21555 Non-Transparent PCI-to-PCI Bridge

Specification Update

December 2002

Figure 6. 304 PBGA (Four-Layer) Package

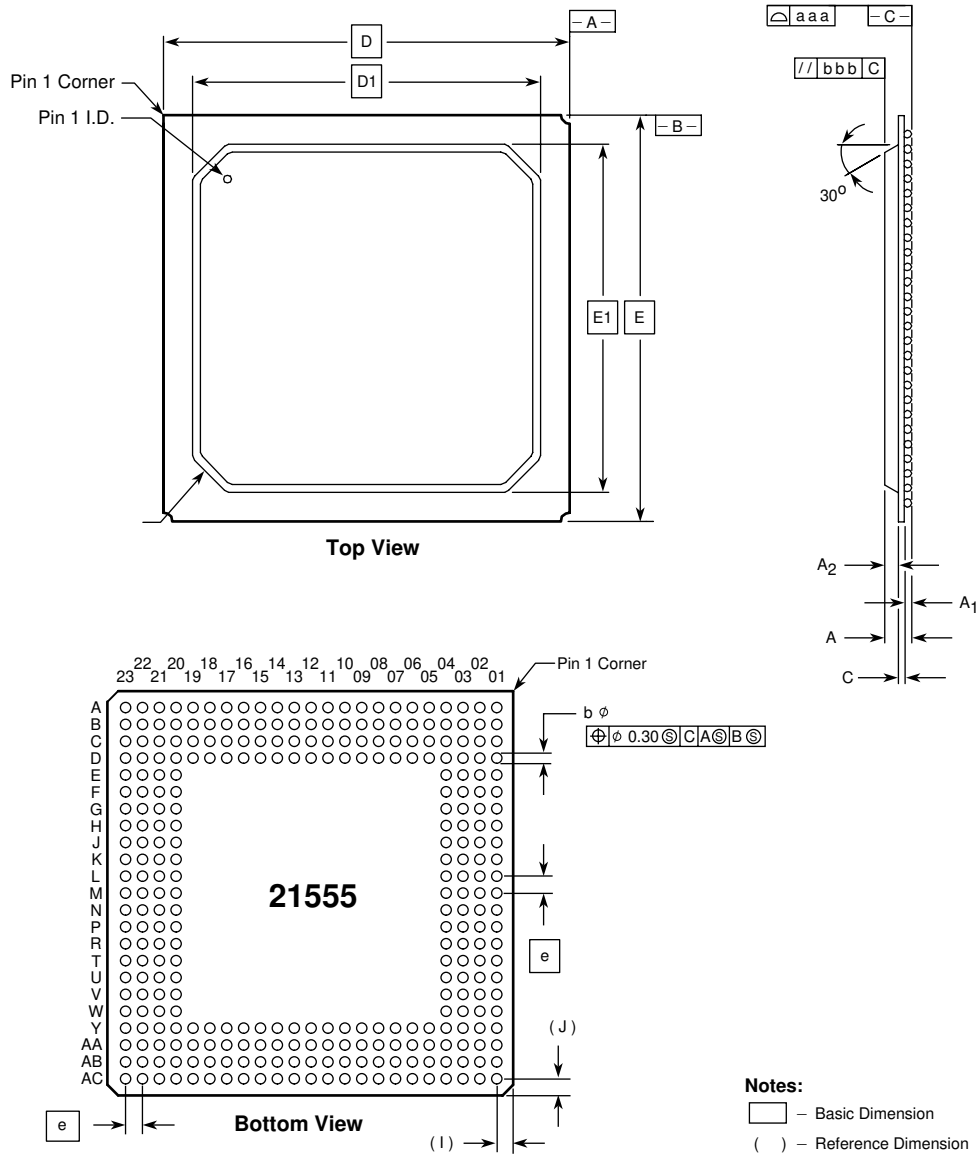
1. **PBGA Package Dimensions for coplanarity changed from maximum value 0.15 mm to maximum value 0.2 mm.**

Per PCN notification 961, the 304-point 4-layer PBGA package dimensions for symbol aaa, coplanarity, are changed from maximum value 0.15 mm to maximum value 0.2 mm.

Issue: The maximum value for symbol aaa, dimension coplanarity, has been changed from 0.15 mm to a value of 0.2 mm.

Figure 1. Node Boundary

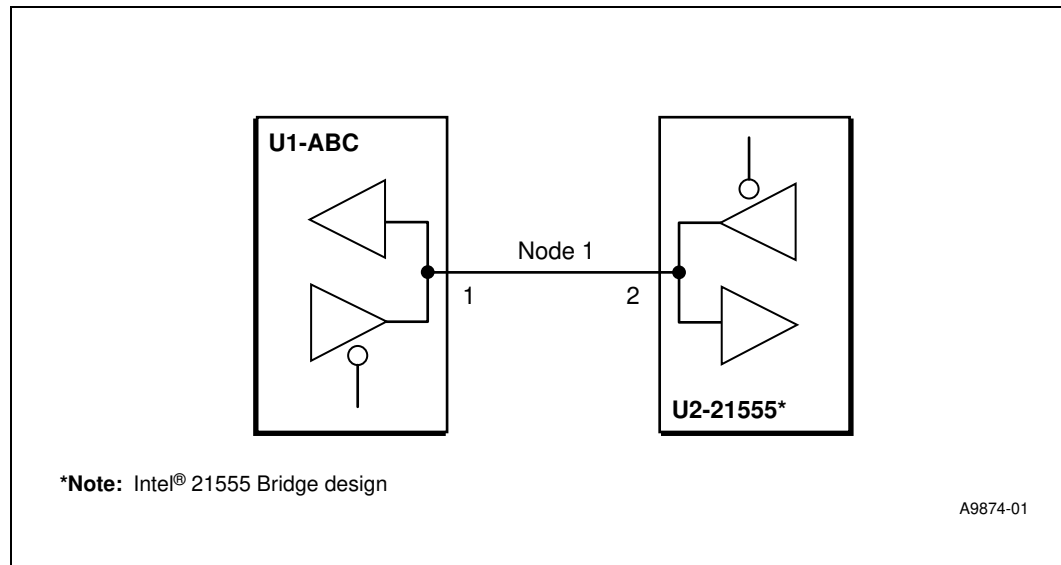
Problem: There is a one cycle delay before valid BSDL data is pushed out to the pins. The problem is due to an incorrect inversion in the equation that generates the JTAG update.

Workaround 2: Standalone boundary scan testers and In-Circuit testers performing chained boundary scan tests, should understand that the Parallel Output UPDATE data, being delayed by one clock, may cause bus contention and back driving during that one clock period, assuming the vectors change bus driving sources in one vector. This is because in chained boundary scan tests, all components execute TAP instructions in Parallel (or lock step), and vector generation algorithms optimize the number of vectors.

To understand the potential issue in detail, refer to the diagram below. Node 1 is a bi-directional node, with U1.1 and U2.2 connected as shown. Assuming that U1 is an IEEE1149.1 compliant device, that U2 is the 21555, and that the control cells of the 21555 were set during the vectors to enable the driver of U2.2 to drive to U1.1 (receiver). When switching drivers from U2 to U1, U2 should tri-state its driver prior to, or at the same time as, U1 enables its driver. Since the 21555 UPDATES its Parallel Outputs one clock late and the control cells which enable U2's drivers are Parallel Outputs which again updates one clock cycle late then U2.2, which will be driving at the same time U1.1 is driving. This contention will happen for one TCK cycle, until U2 UPDATES its parallel outputs. The period of this contention is dependent on the TCK frequency rate.

Status: Fixed.This behavior has been corrected in the 21555AB/BB Step A3 device.

Figure 12-1. Signal trst_l States

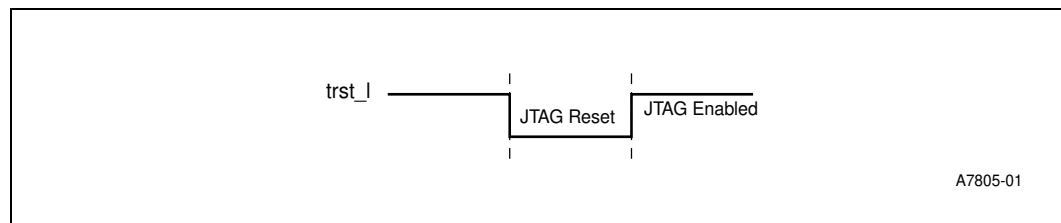
13. **Change to Initialization Section 12.2.1 and JTAG Description**

Issue: Change to second paragraph. Also made a change to normal operation description note for JTAG below Figure 12-1. The section now appears as follows:

The test access port controller and the instruction register output latches are initialized and JTAG is disabled while the **trst_l** input is asserted low (see Figure 12-1). While signal **trst_l** is low, the test access port controller enters the test-logic reset state. This results in the instruction register being reset which holds the bypass register instruction. During test-logic reset state, all JTAG test logic is disabled, and the device performs normal functions. The test access port controller leaves this state only after **trst_l** (low) goes high and an appropriate JTAG test operation sequence is sent on the tms and tck pins.

*Note:*Prior to normal 21555 operation, this signal must be strobed low or pulled low with a 1kΩ resistor.
